UNITED STATES OF AMERICA  
NUCLEAR REGULATORY COMMISSION

In the Matter of	)	
	)	
CROW BUTTE RESOURCES, INC. ,	)	Docket No. 40-8943-MLA-2
	)	ASLBP No. 13-926-1-MLA-BD01
(Marsland Expansion Project)	)	
	)	August 17, 2018

**UGLALA SIOUX TRIBE'S**  
**INITIAL POSITION STATEMENT**

**OST Contention 2: Failure to Include Adequate Hydrogeological Information to Demonstrate Ability to Contain Fluid Migration**

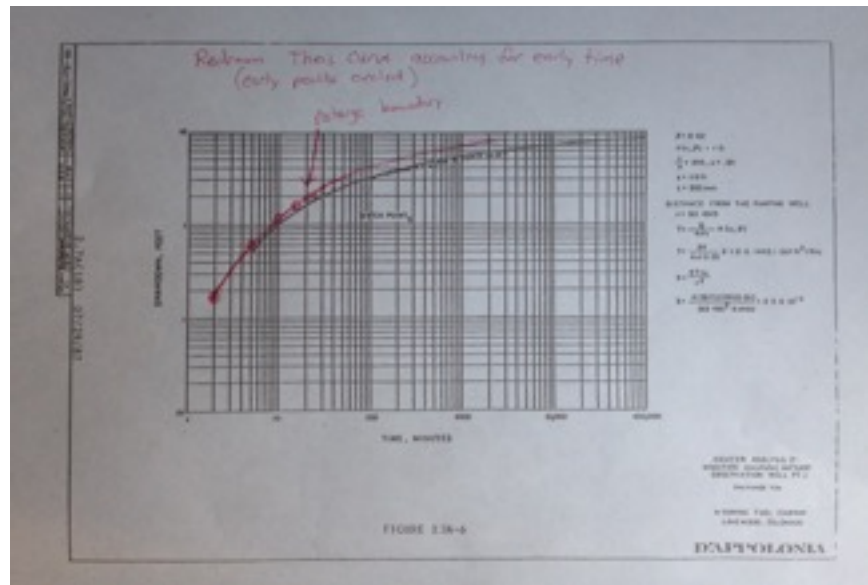
G. The report does not make it clear if the actual aquifer thicknesses were used to calculate transmissivity or only the average aquifer thickness.

H. From Figure 2.6-9 [CBR008 at 76], the thickness of the Basal Chadron Sandstone varies from 21ft to 91ft across the site; the screened intervals of the monitoring wells varied from 22 to 50 feet giving the possibility that these wells did not measure results solely from the entire thickness of that aquifer, or conversely, in part measured water derived from formations other than the Basal Chadron Sandstone.

OST005 at 4: Dr. Kreamer re-drawn Figure 2.7A-6, with Theis type-curve matching early time in red. Early data points are circled – late time data below type curve indicates recharge.

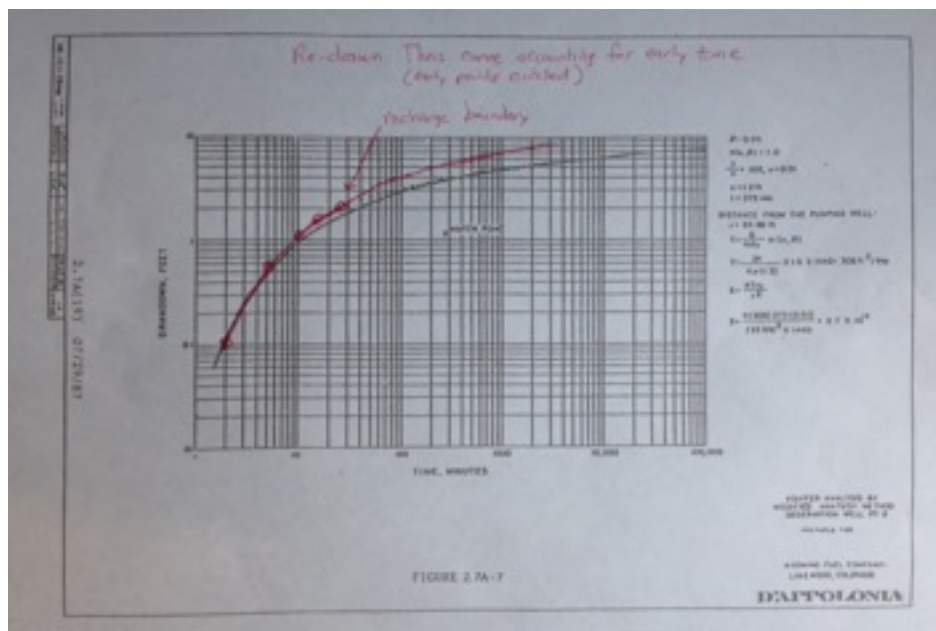
during the pumping test.” Additionally, Dr. David Kreamer in testimony regarding pumping test one showed departure from the classic Theis curve consistent with leakage (See Exhibits 1 and 2 below). [OST005 at 4] This same departure is evident in the MEA pumping test. [OST009 at 80-96]

OST005 at 4: Dr. Kreamer re-drawn Figure 2.7A-7, with Theis type-curve matching early time in red. Early data points are circled – late time data below type curve indicates recharge.

**OST005 at 7: Cooper Jacob semi-logarithmic plot (Figure 2.7 -14) modified (in red) by Dr. Kreamer to show early drawdown. A recharge boundary appears at approximately 30 minutes, and forms a line of late time data to the right of the red early data trend.**

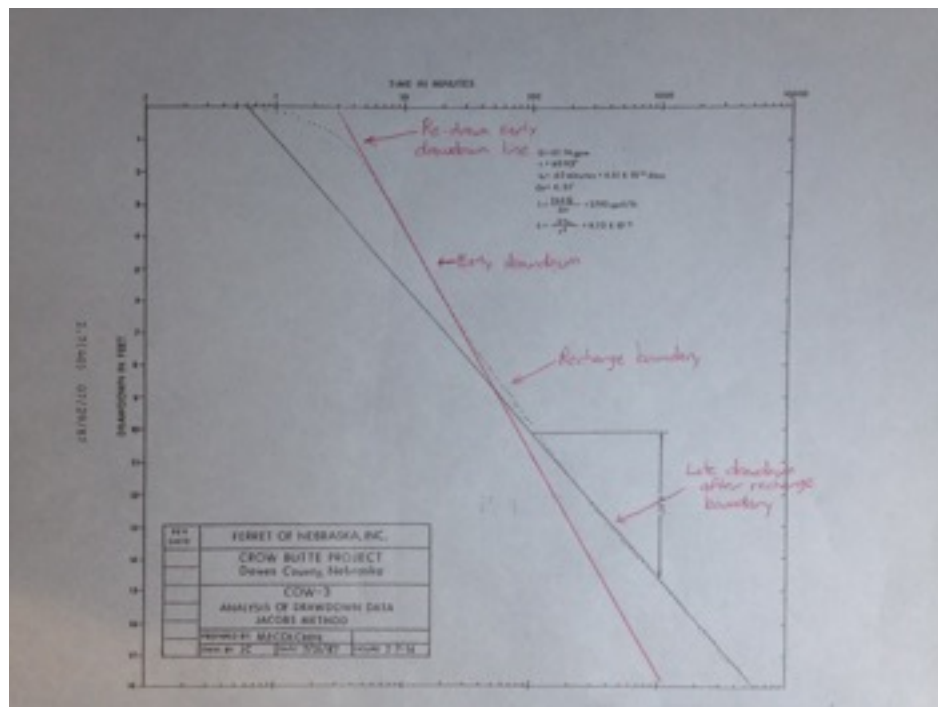
Historical Aquifer Test 2 from CBR also showed a recharge boundary. [OST007]. Kreamer Testimony September 2015 Exhibit 3 below [OST005 at 7] is Figure 2.7-14 with additional early time interpretation, showing a distinct break point at about 30 minutes, signifying a clear recharge boundary, which can be interpreted as additional vertical flow. Residual time-drawdown data for COW-3 also exhibits this recharge boundary (Figure 2.7-20 on page 2.7 (46)). [OST007 at 33].
